Metropolis Planning and Design

Representations Planning Application Ref: 2017/55233/P

40a Parkhill Road

Image 1 - Extent of Proposed Basement into Front Garden

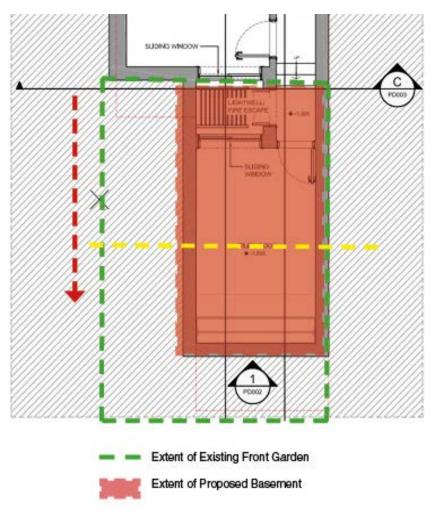
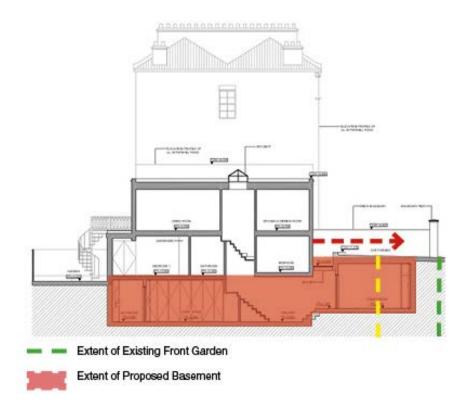
- 3.5 It is clear from the scheme drawings that the proposed basement footprint is significantly larger than the existing ground floor plan, and in no way therefore can the proposals be considered to be subordinate to the host dwelling.
- 3.6 Amongst a range of considerations, Policy A5 specifically notes at criterion (k) that basement development should '*not extend into or underneath the garden further than 50% of the depth of the garden*'.
- 3.7 It is evident from the application plans that the depth of the basement projection into the front garden space is approximately 6 metres from the line of the front façade, which therefore extends significantly beyond the 50% requirement set by Policy A5.
- 3.8 This contravention is illustrated in the following annotated images.
